# 1961 Corvette: Chevrolet Product Engineering Technical Information: Spark Plug Electrode Interference With Piston

**Subject:** Spark Plug Electrode Interference With Piston  
**Model and Year:** 1961 Corvette Models Equipped with Fuel Injection  
**Source:** Chevrolet Service and Mechanical Department - Technical  
Information - 1961 Product Data Book  
**Bulletin Number:** Page 3-4 - Section VI - Group 2  
**Date:** 7/8/61

Reworking Piston Dome - 1961 Corvette Models Equipped With Fuel Injection

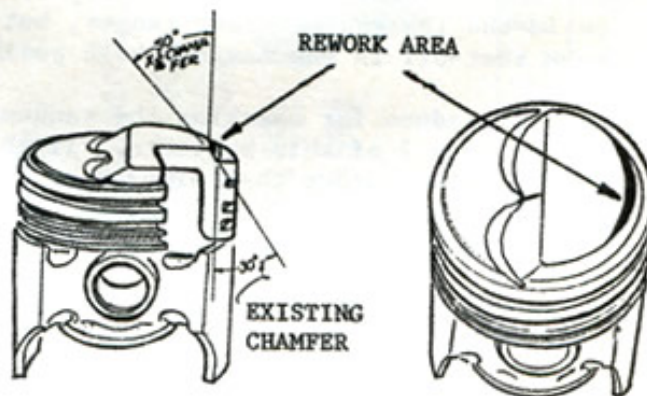
An interference condition between the spark plug ground electrode and piston dome may occur on 1961 Corvette Models equipped with fuel injection. This interference results in a bent electrode which causes insufficient spark plug gap, engine miss and subsequent poor performance.

The condition was corrected in Production effective 5-15-61 (engine date stamp F-0515) by removing 1/16" of the piston dome at the contact area as shown in the following sketch. The size of the area to be removed is approximately 1/16" thick, 1/8" wide and 1-1/2" long machined at a 50° angle. Only the top half of the dome chamfer should be removed with the lower portion remaining at the existing 30° angle.

In the event an 11:0-1 compression ratio engine equipped with fuel injection is being overhauled or if the cylinder heads are removed, each piston dome should be filed or ground off approximately 1/16" to prevent spark plug electrode interference. if only the heads are removed, the pistons should be at TDC and grease applied to the top of the pistons to insure complete remove of filings.

Whenever engine replacement is required, either partial or fitted blocks or if service pistons are being installed, the pistons should be reworked prior to installation.
